Subject: Installation of refrigeration equipment at 687 Congress St.,
First National Stores, Inc.

Subject: adjustment of eccentricity of first
story column in First National Stores, Inc.
retail store under construction at 687 Con-
gress Street

Subject: Permit for construction of retail
store for First National Stores, Inc. at
637 Congress Street

Subject: Application for permit for construction of retail store at 637 Congress Street

Subject Basement Walls

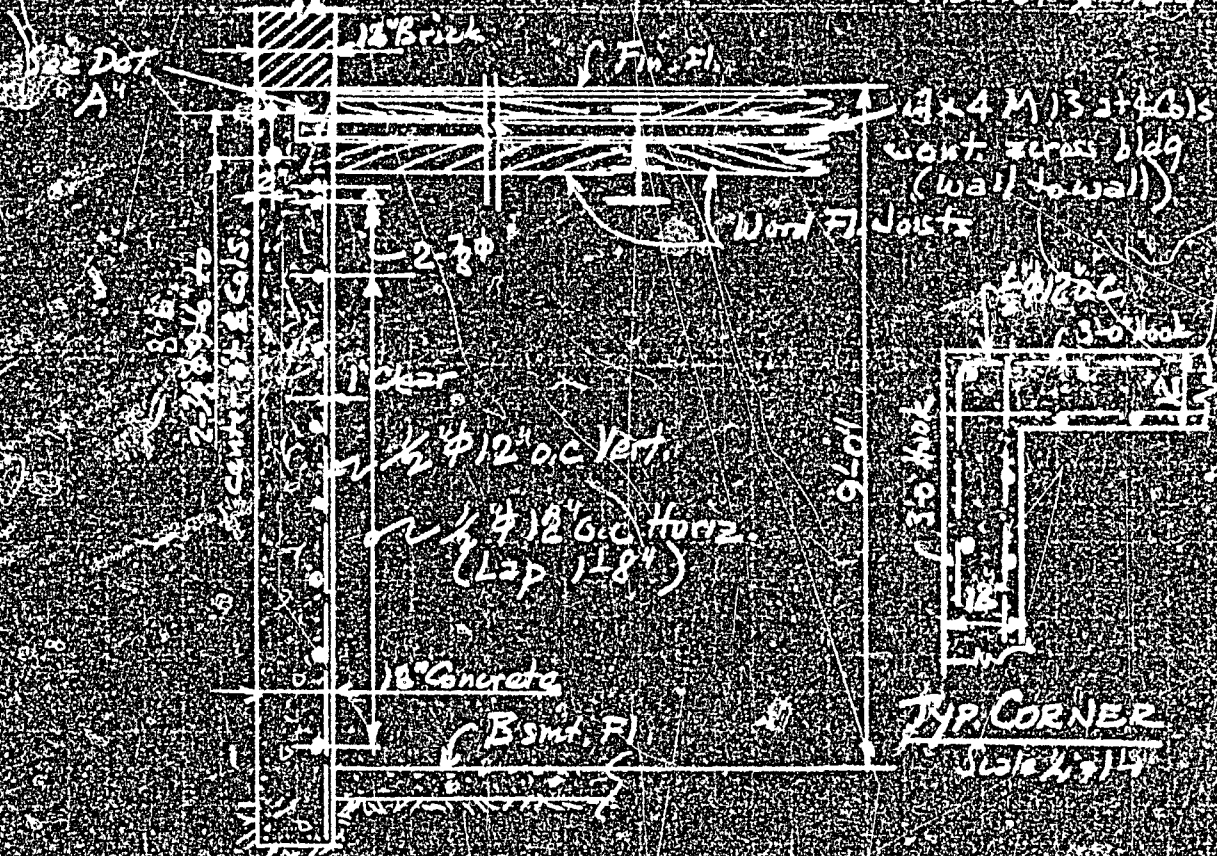
We are in receipt of your letter with calculations and design for reinforcement of the 12" concrete foundation walls of the building to be erected at the above location. This design would appear to take care of the conditions involved and this letter may be considered as removing the limits set upon the work when the permit for excavation and foundation was issued. Of course the contractor will need to be furnished with a plan showing the method of reinforcement to be provided for his use in construction of the wall.
